Re: 3404 Stanford Dr NE Addition
3404 Stanford Dr NE
Traffic Circulation Layout
Engineer's Stamp 07-28-16 (G16D151)

Based upon the information provided in your submittal received 07-29-16, the above referenced plan cannot be approved for Building Permit until the following comments are addressed:

DRAINAGE AND TRANSPORTATION INFORMATION SHEET (REV 10/2015)

3404 STANFORD DR NE ADDITION TRAFFIC CIRCULATION LAYOUT			
DRAWING:	DRAWN BY:	DATE:	SHEET #
201606-SP.DWG	SH-B	07-28-2016	1

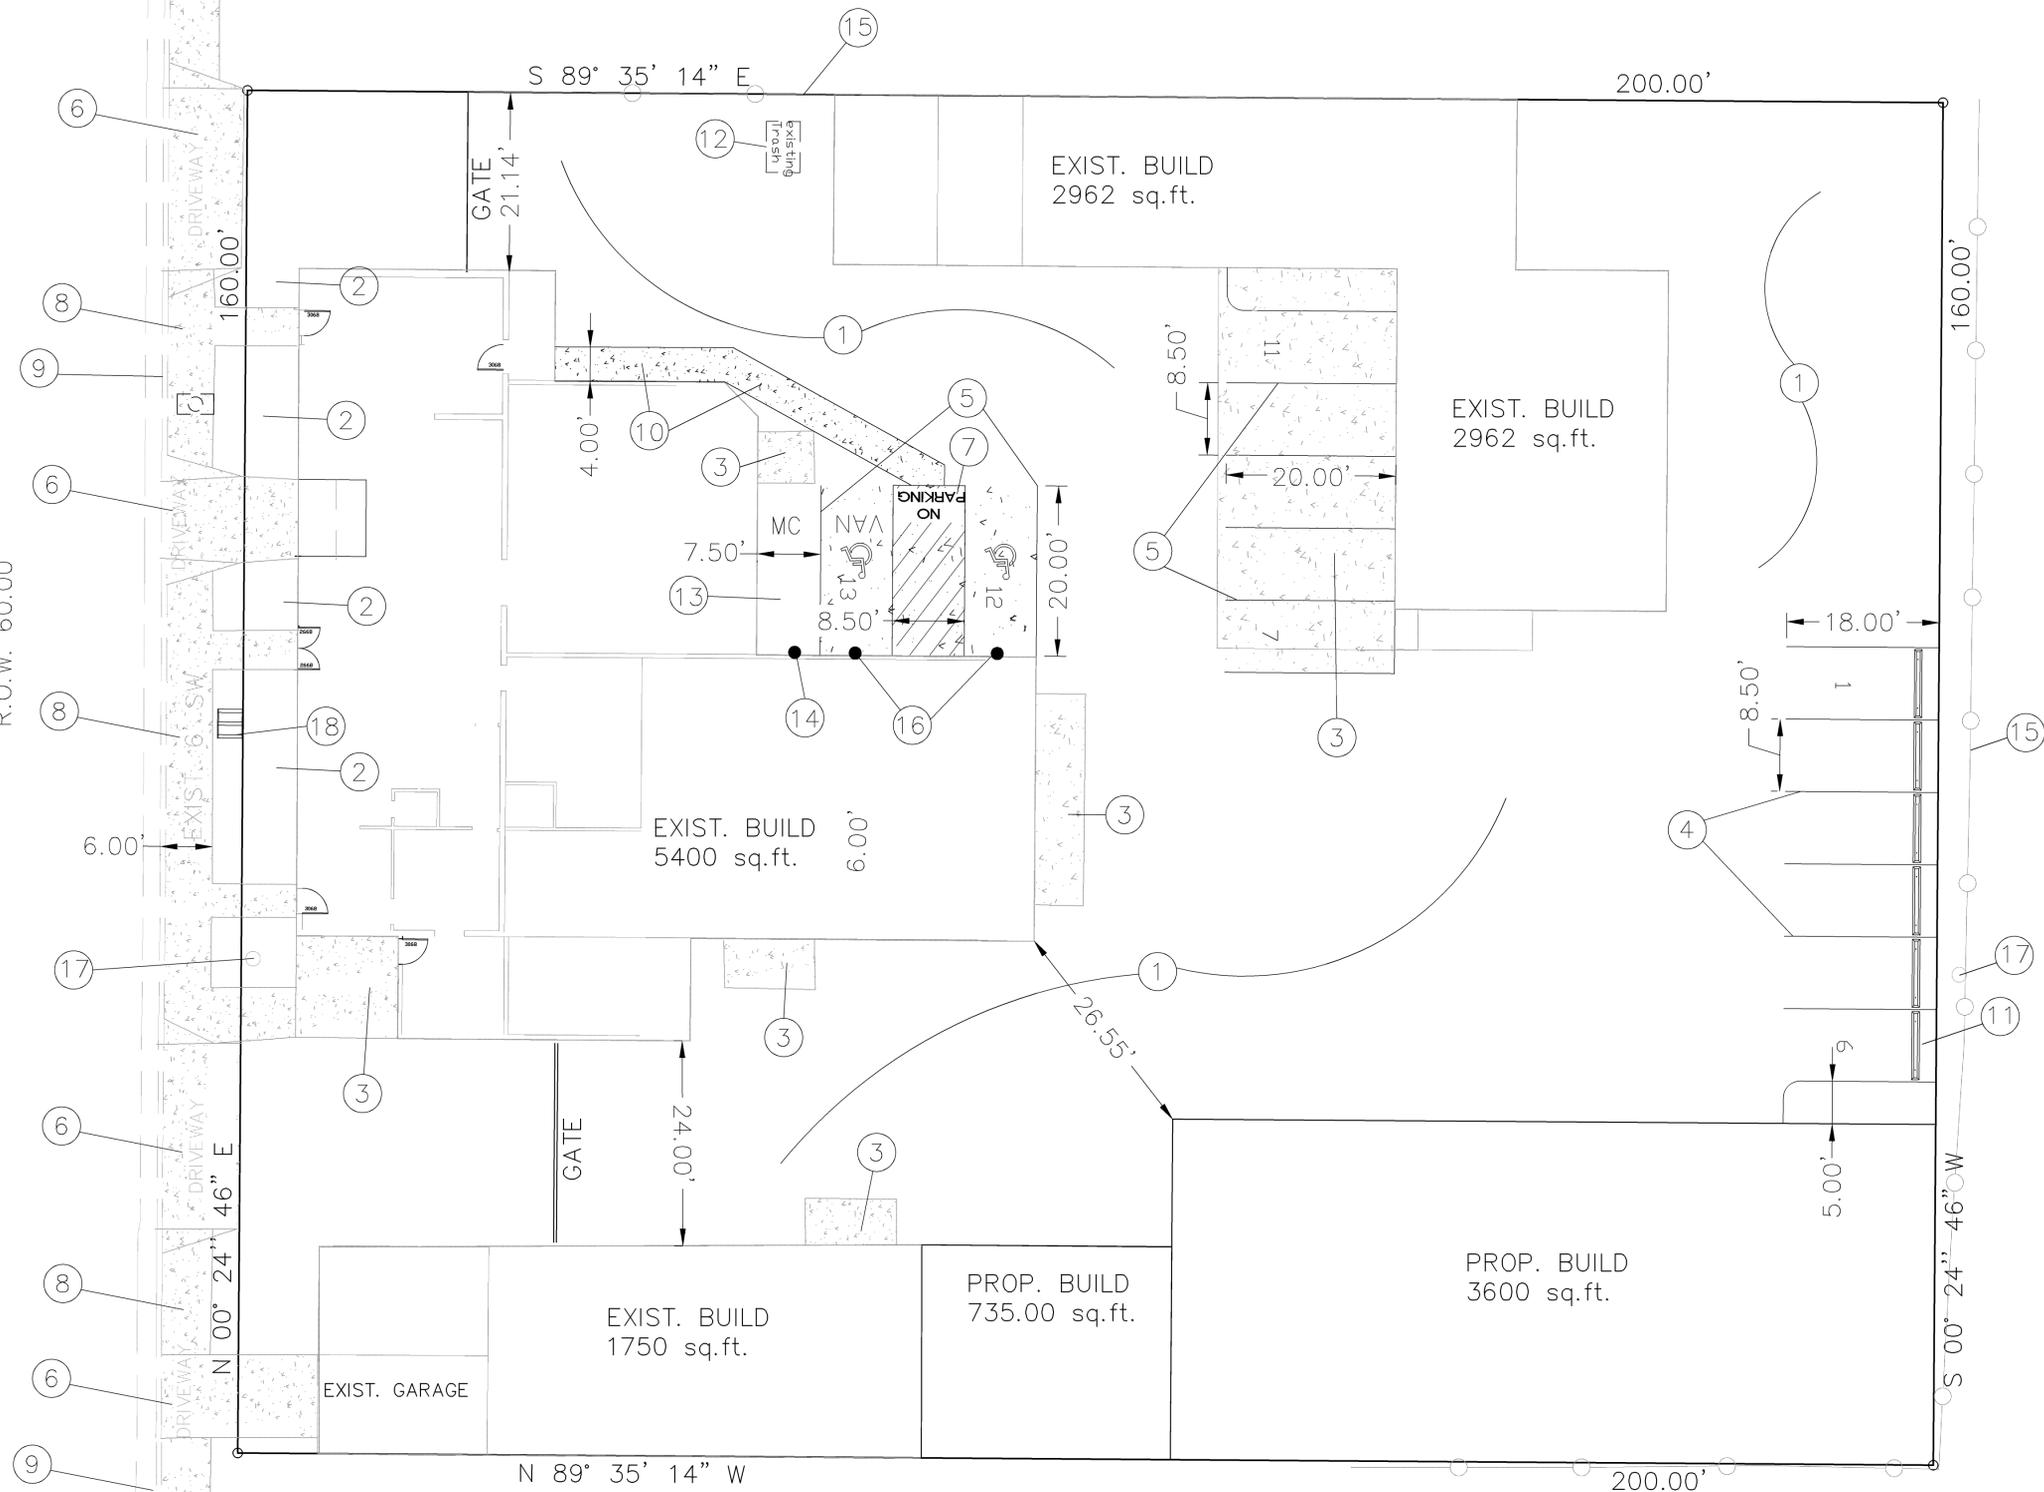
1. Show all drive aisle widths and radii.
2. List radii for all curves shown; for passenger vehicles, the minimum end island radius is 15 ft. Landscape island radius for delivery trucks, fire trucks, etc. is 25 ft. or larger.

3. Per DPM, a 6 ft. wide ADA accessible pedestrian pathway is required from the public sidewalk and handicapped parking to the building entrances. Please clearly show this pathway and provide details.

4. Per DPM, a 6 ft. wide ADA accessible pedestrian pathway is required from the HC parking stall access aisles to the building entrances. Please clearly show this pathway and provide details.

5. All sidewalks along streets should be placed at the property line.
6. Service vehicle and/or refuse vehicle maneuvering must be contained on-site; provide a copy of refuse approval.

7. Please specify the City Standard Drawing Number when applicable to all curb cuts and ramps.
8. Work within the public right of way requires a work order with DRC approved plans. Please add a note on the plan stating "All improvements located in the Right of Way must be included on the work order."

9. See Chapter 23, Section 6 of the City of Albuquerque *Development Process Manual*, for appropriate drive pad widths.
10. All broken or cracked sidewalk must be replaced with sidewalk and curb & gutter. A build note must be provided referring to the appropriate City Standard drawing.
